FOUNDATION INVESTIGATION REPORT

Highway 9, West of Highway 50

W.P. 73-83-01, Central Region

Subject: Geotechnical Considerations
Hwy 9 - West of Hwy 50
W.P. 73-83-01
District 6, Toronto

TRIAL 2 - NO FROST COVER FOR FACE WALL
(NOM. 300 mm BELOW GRADE)

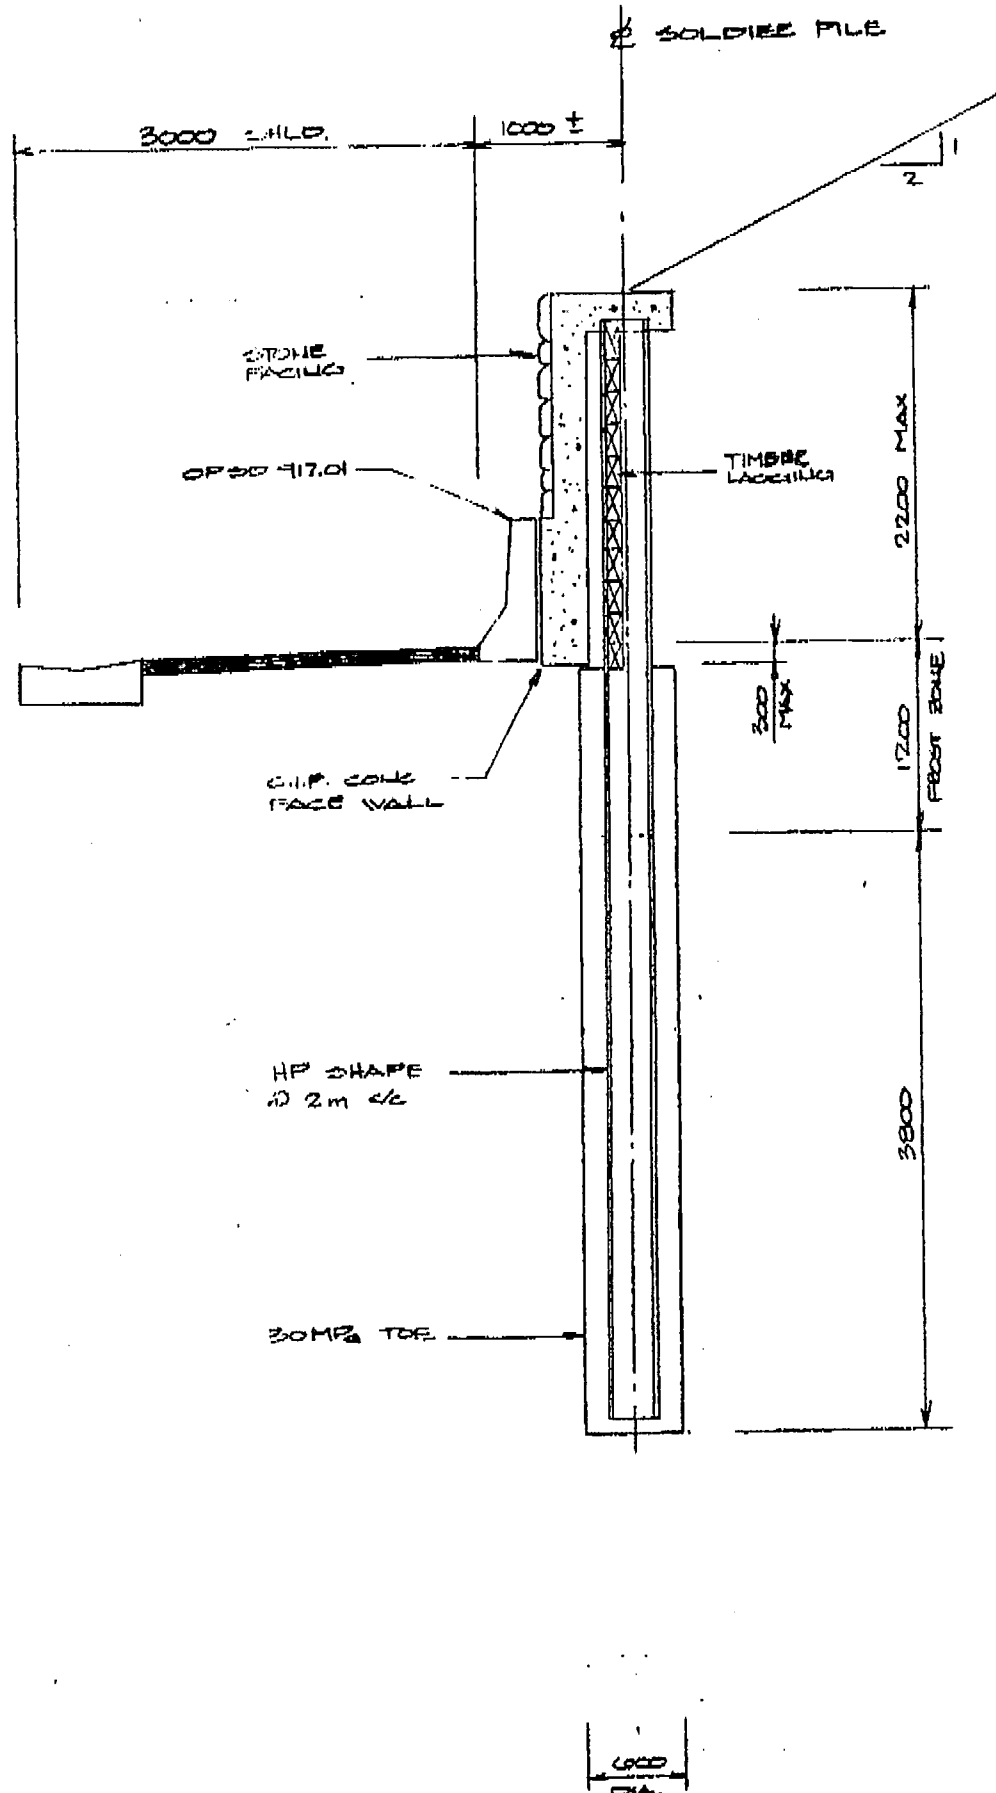
COMMENTS: W.P. 73-83-01 SOLDIER PILE WALL - TRIAL 2
(NO FROST COVER FOR FACE WALL)IF THIS TRANSMISSION IS RECEIVED INCORRECTLY, PLEASE CALL THIS FAX OPERATOR
IMMEDIATELY AT (416) 235-5423 EXT. # 0139

Schematic Cross-section for Reinforced Earth Wall
(N.T.S.)

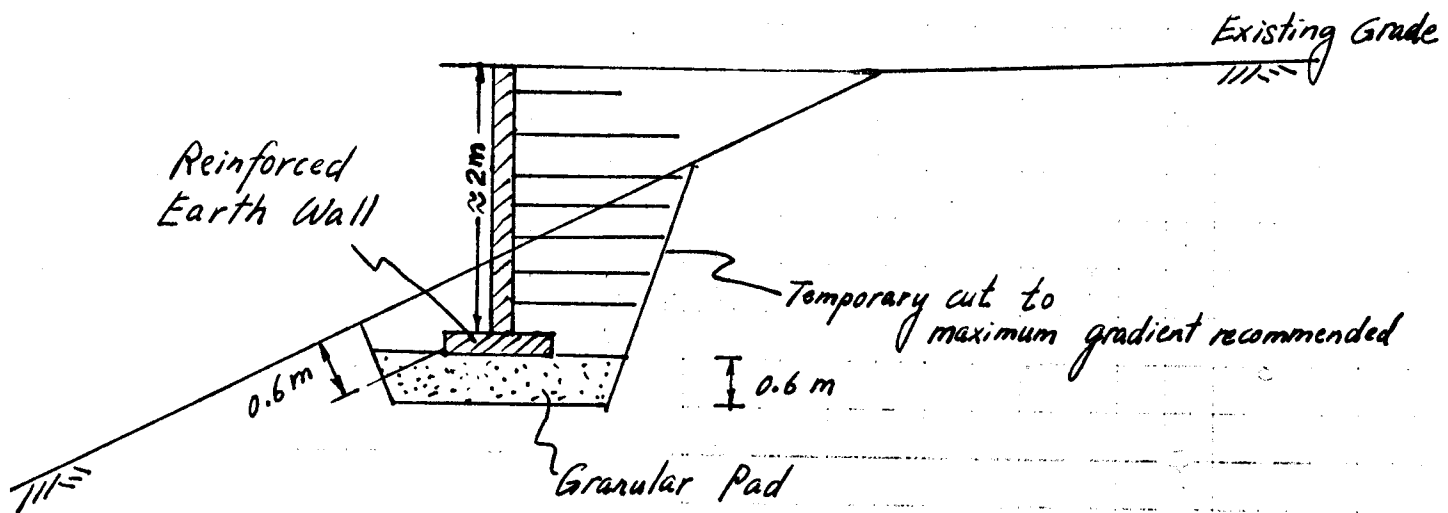
A meeting was held in this office on 92 05 26 to discuss various alternatives of ground support for highway widening at a few concerned locations for the above project, in particular the area around Sta 10+575 where Niagara Escarpment Commission has objections over the presently proposed fill option. The results of our discussions are summarized as follows :

1. The alternative of constructing a reinforced concrete wall at mid height of the slope was discussed and generally considered not cost effective as a major structure on slope is required to support a sloping ground above. There will be construction difficulties as well.

2. It is considered that constructing a flexible retaining wall such as a reinforced earth wall at the top of the slope to support the proposed highway widening is a more feasible solution. Due to the granular nature of the existing fill, it is envisaged the wall can be founded within the fill stratum. The wall base may be subjected to some differential settlements due to the erratic nature of the existing fill. It is believed that the reinforced earth wall may be designed to tolerate the movements.

3. The retained height of the wall is about 2 m. The wall should be founded at least 0.6 m below the surface of the existing slope, on a compacted granular pad of minimum 0.6 m thickness as shown on the attached sketch. The details of the reinforced earth wall should be conservatively designed to minimize movements. No further foundation investigation is necessary if this alternative is adopted.

4. The possibility of changing the highway design from rural standards to urban standards was also put forward to reduce the required width of widening and hence the height of the wall. If this is possible, please notify our office.

5. It was agreed that Structural Section will work together with William L Sears & Associates and come up with a retaining wall design package for all the concerned areas and this office will then provide foundation inputs accordingly.
